CITY OF BOULDER
PLANNING BOARD MEETING AGENDA
DATE: October 30, 2014
TIME: 6 p.m.
PLACE: Council Chambers, 1777 Broadway

CITY OF BOULDER
PLANNING BOARD AGENDA ITEM
MEETING DATE: Oct. 30, 2014

Project Name: Reve Pearl District
Location: 3000 Pearl Street; 2170, 2100 30th Street and 2120 32nd Place
Size of Tract: 6.01 Acres (186,676 square feet)
Zoning: Business Regional-1 (BR-1) and Industrial General (IG)
Comprehensive Plan: General Business (GB) on the south and Mixed Use Business (MUB) on the north.
Key Issues: Staff is recommending the following key issues for discussion of the Concept Plan:

Figure 15: Current Concept Above Compared to Original Concept Below

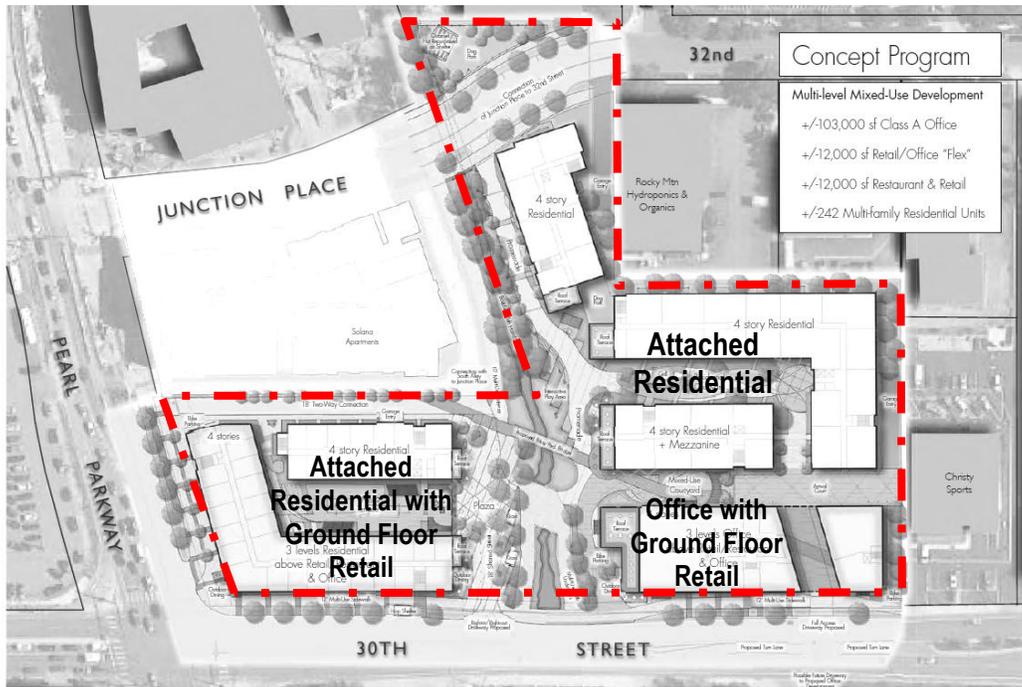
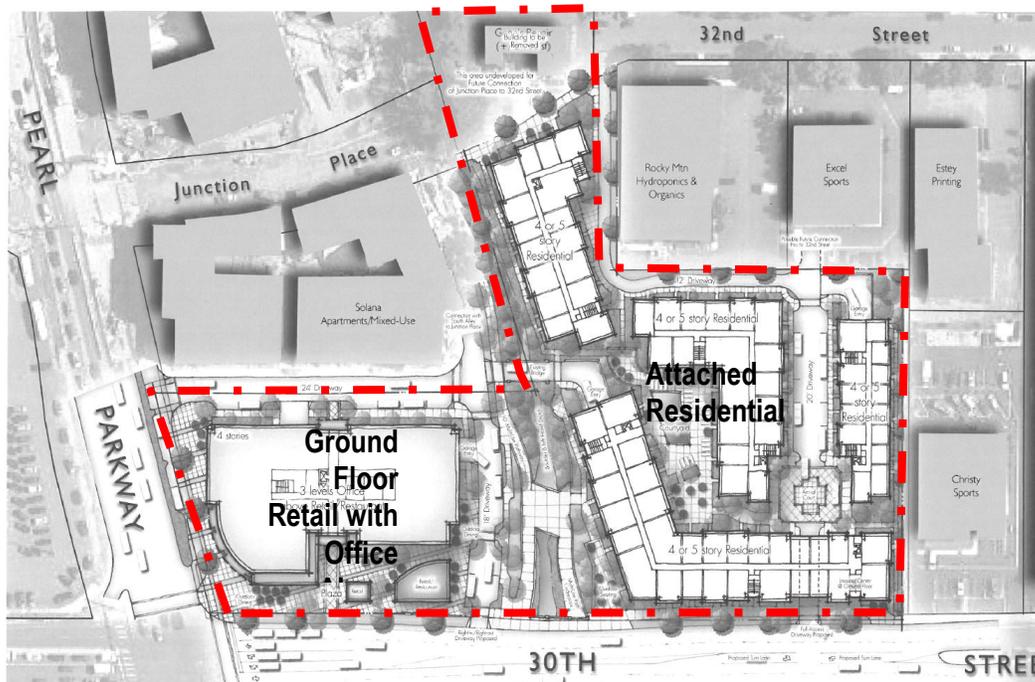
At the June, 5, 2014 Planning Board hearing, the board discussed several key issues regarding the original Concept Plan. The meeting minutes in their entirety are available at the following weblink: [June 5, 2014 PB Hearing Minutes](#). At the hearing, the Planning Board presented several suggestions to the applicant with regard the building and site design and recommended the applicant submit a second Concept Plan to address them. Among the key suggestions was to include residential over retail on the northwest corner to improve compatibility with the TVAP Guidelines. Below in Figure 15 is a comparison of the current concept plan with primarily residential and retail at the northeast corner and office fronting 30th Street on the south side of the site with residential behind; compared to the original concept plan with office at the corner of 30th and Pearl streets and all residential land uses on the south side of the site.

Specific recommendations from the Planning Board for the original concept plan are summarized in the following:

- There was interest in seeing the ditch function as an amenity for residents and retail spaces.
- Include family friendly and other unit types
- Consider including family friendly amenities such as playgrounds and daycare.

- Create pedestrian interest along 30th Street and activate the streetscape.
- Provide quality bike parking.
- Maintain a sense of some openness and solar access.

- There was some willingness to consider land use change but it is not a given. There is a question whether a land use change would be made through Comp Plan change.

Regarding use of the ditch function as an amenity for residents and retail space, the second Concept Plan submittal illustrates a number of concept sketches of the design of the buildings and open space around the ditch as an amenity, an example of those sketches is shown in Figure 16.

Regarding family-friendly and other unit types, the applicant indicated that the residential buildings internal to the site would consist of more two and three bedroom units catering to the needs of families in the area. Staff notes that the discussion at Planning Board by some of the board members wasn't just about size of the apartment units, but was also about building configurations that might allow for ground floor access to units by families.

Figure 18: Excerpt from Concept Plan Book illustrating potential urban style playgrounds

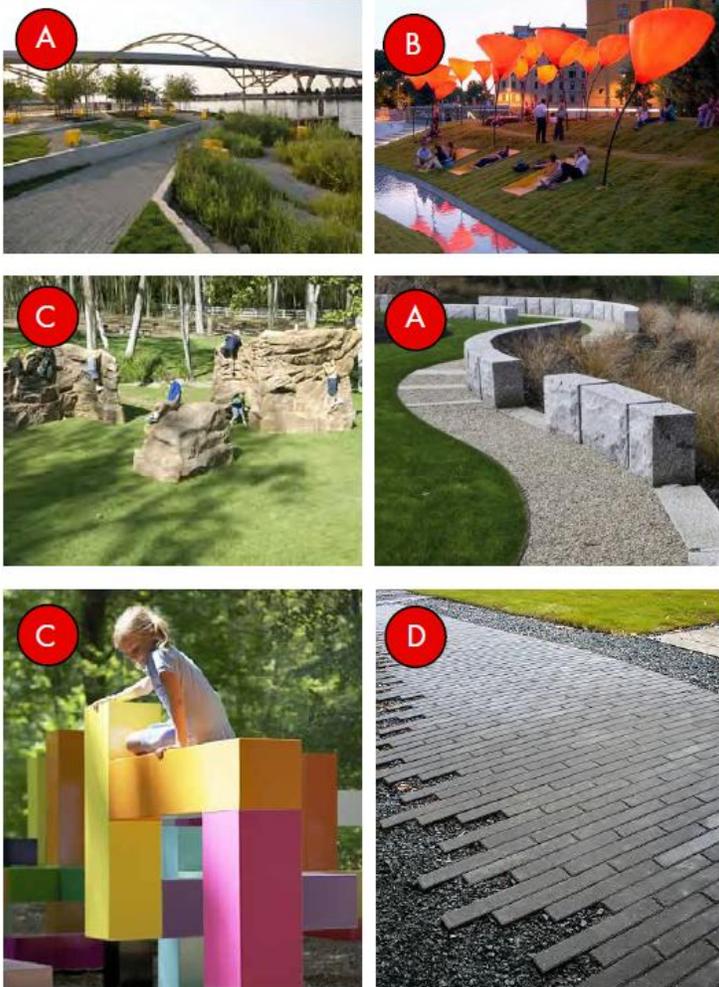
Similarly, with regard to the creative “urban playgrounds” that are illustrated in precedent images, shown in Figure 18 as project plans progress identifying areas that provide family oriented amenities such as playgrounds and daycare should be considered.

Figure 21:
Illustrations of Activated Streetscape
Planned along 30th Street

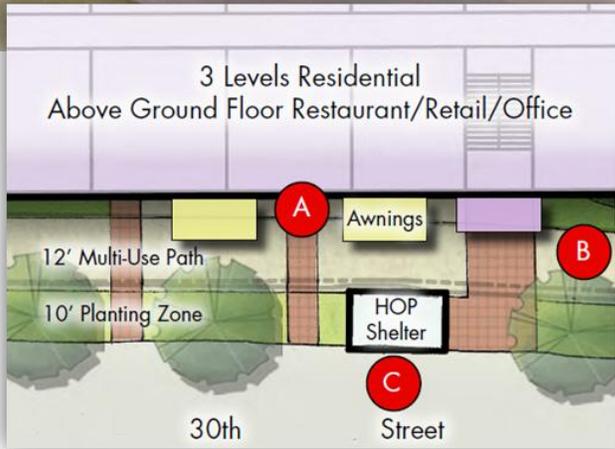
As also shown in Figure 21, a rendering that is presented on page 27 of the concept plan book illustrates the type of storefront and activity planned for the ground floor along 30th Street. One consideration that staff notes with regard to ground floor uses is that in the options of the ground floor presented, office is indicated as one of the options. The BVRG guideline 5.1.E, further discussed in Key Issue 4, recommends that interior spaces such as dining areas and merchandising displays "spill" onto walkways and plazas on the ground floor. Inherent in that guideline is the assumption that the ground floor will be activated by retail types of uses that create greater activity than offices such as banks or other low turn-over types of uses. As project plans progress, the applicant should look to ways to plan for active uses on the ground floor. Understanding that the more active uses could come in over time, the applicant should consider ensuring higher ceilings on

the ground floor along with storefront window systems to establish the retail vernacular that can adapt over time. Figure 22 illustrates an elevation along Pearl Street with non-residential on the northwest corner of the ground floor.

**Figure 23:
TVAP Connections Plan
Compared to the Concept Plan**

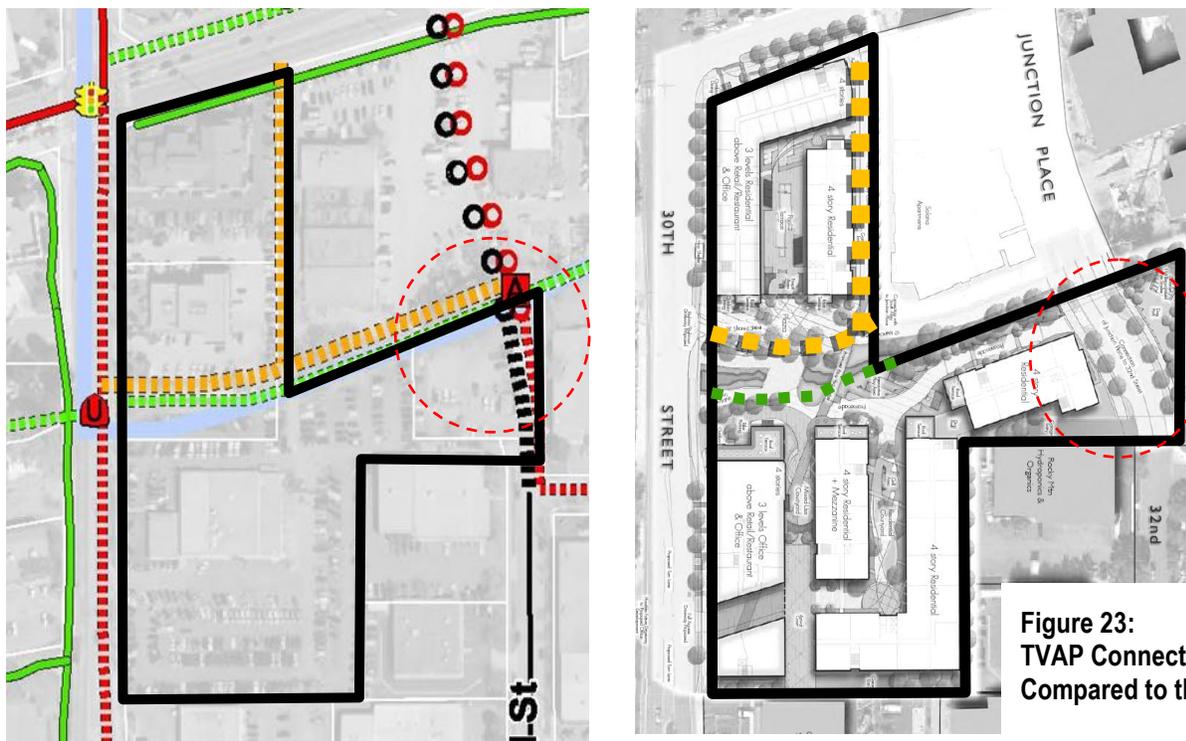
One of the Key Issues for discussion of Transportation Connections is the overall circulation plan for the site. Staff recommends access to the site be from a combination of a right-in, right-out at 30th Street on the north side of the ditch, a full movement access to 30th Street on the south side of the project that aligns with the proposed access point across the street and a full movement access with Junction Place / 32nd Street on the east side of the project. Another of the part of the circulation key issue is the lack of definitive illustration of the extension of Junction Place and the bridge connection over the ditch. This connection is shown on the TVAP connections plan with the symbol: **A** he applicant is illustrating the bridge connection. A comparison of the required connection and how comparable connections are shown on the concept plan is shown in Figure 23. The circle represents the location of the future bridge. It is important for this project to provide a clear connection to Junction Place, which then provides a clear path to both Pearl Parkway and the transit center that is currently under construction.

The proposed concept plan appears to meet the intent of other TVAP connections, in particular providing the local roadway connections shown within the site, albeit in configurations that may require amending the connections plan slightly. In the locations of the two local roadways shown on the site, the applicant is illustrating a roadway with on-street parking on the northeast side of the site. The center of the site, along the ditch, is illustrated as a shared street, or like a “woonerf” where bikes and pedestrians are provided the space and autos are “guests.” The applicant illustrates how, on certain days, this space could accommodate food trucks to amenitize the space or create small food kiosks that would align the ditch and bike path, as shown below. This configuration is compelling and could meet the vision of TVAP, but would require a request to amend the TVAP Connections Plan in Site Review.

Figure 25a and b
 Site Location with Natural Grade (above in 1958 USGS topo) compared to Altered Grade today (below)

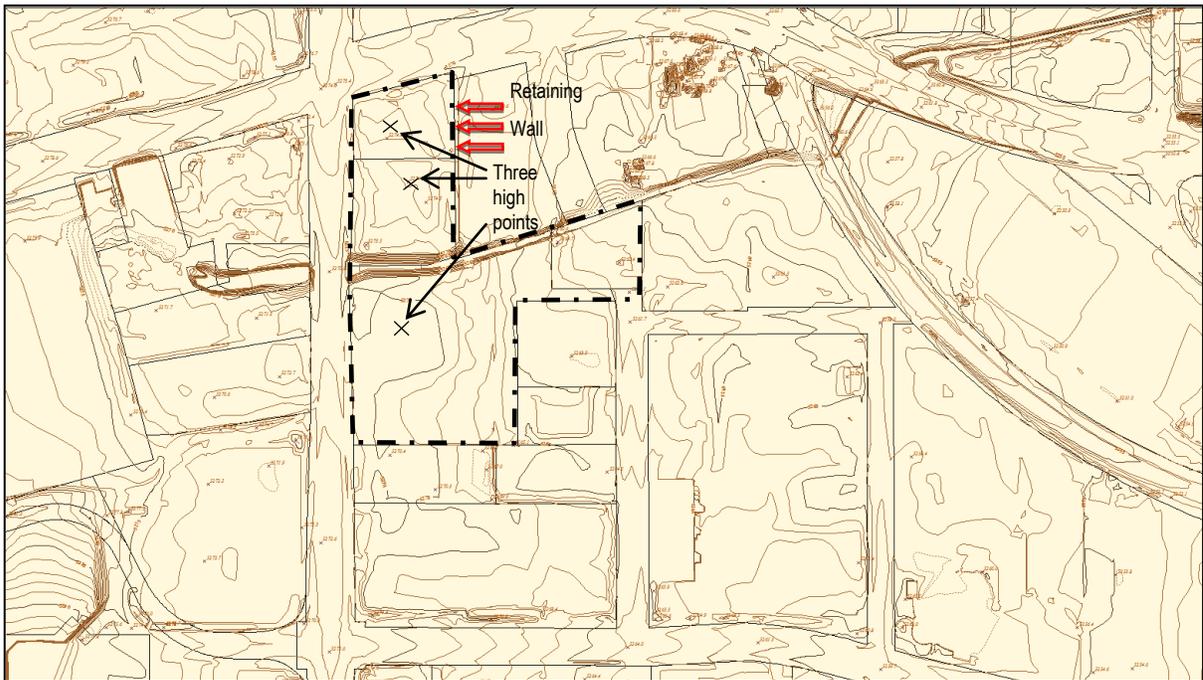
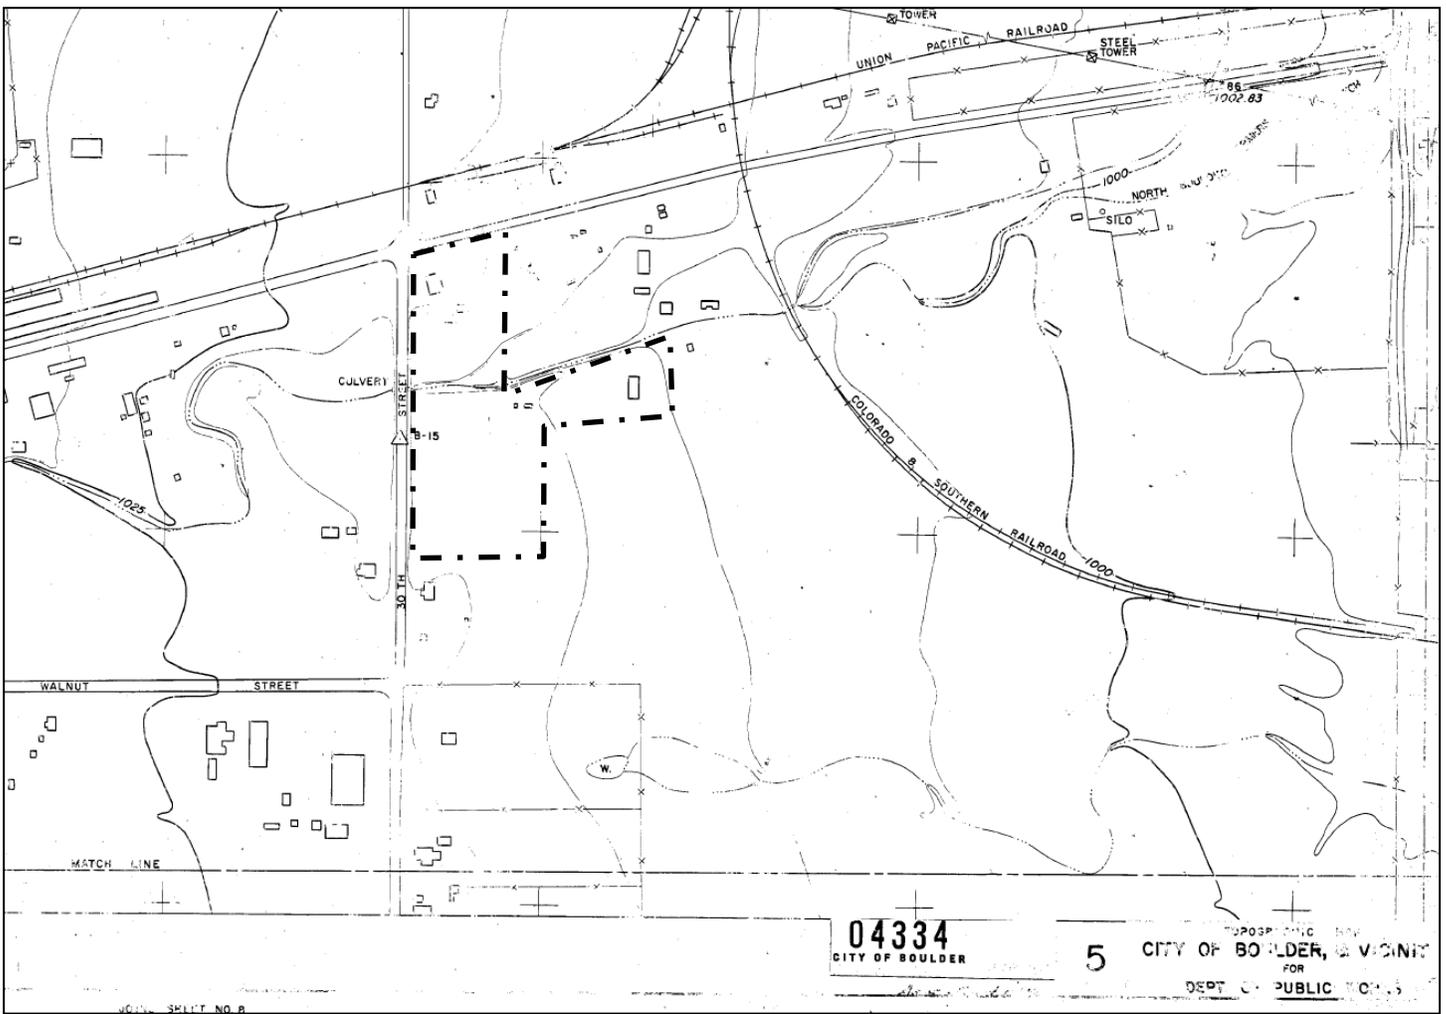
As noted in the previous Concept Plan, is the proposal to return the existing site’s altered topography back to the original grading, shown in Figure 25a from a 1958 USGS topographic map. As is understood, the site was altered a number of years ago with fill added to bank the site toward 30th Street and create an auto display area, as can be seen in the current topographic map in Figure 25b. The plan to remove the fill and retaining wall will help to bring to fruition, the proposed local access road at the east side of 3000 Pearl property as envisioned in TVAP. As shown in Figures 26a and 26b is the retaining wall on-site and where the wall is located in relation to the TVAP connections plan. The existing retaining wall usurps the opportunity to create the connection for both properties to use that connection without extraneous pavement. Prior to Site Review, the applicant and the adjoining property owner at Solana Apartments will be required to establish an agreement on how best to configure the access between the two properties, with city approval of that agreement.
